TN_161 FT4222H Errata Technical Note

Document Reference No.: FT_001198

Version 1.5

The current revision of the FT4222H series is **Revision D, released April 2018.**

Figure 3.1 Quad SPI with Multi Write Phase

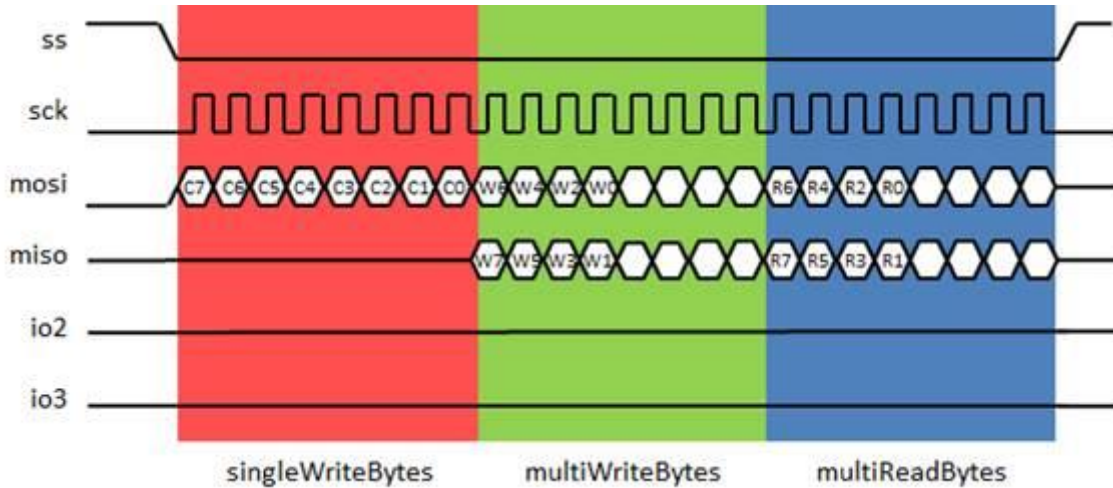
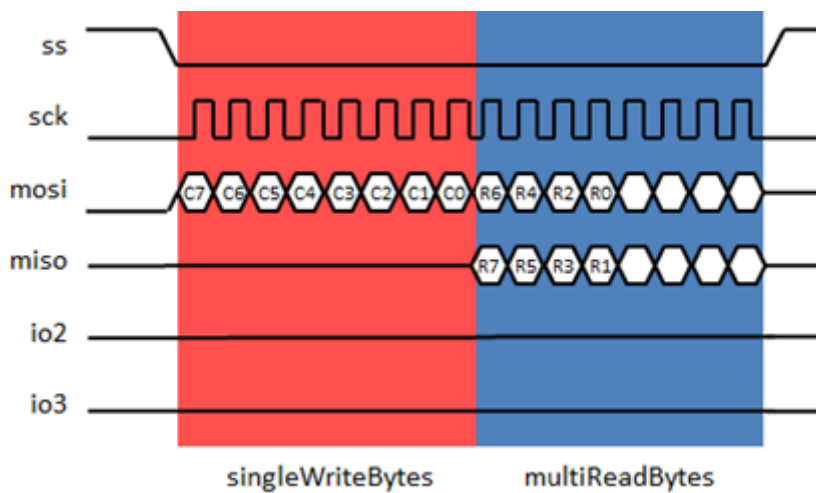
When accessing Toshiba flash with SPI Master Quad mode, FT4222H will hang without giving any responses.

FT4222H operates as master with supporting Dual or Quad SPI with three phases as illustrated in Figure 3.1.

As shown in Figure 1 'C', 'W' and 'R', correspond to "Command Phase", "Write Phase" and "Read Phase", where there are information/data in all three phases that are to be exchanged.

Some flash devices operate with single write and multi read protocol but without the multi write phase as illustrated in Figure 3.2:

Write Phase has no information/data to transfer. This combination of operating mode is not supported with Rev A, B and C.

In SPI Master Quad mode, the operation of single write with quad read was not supported. No workaround was provided, this feature is implemented with Revision D.
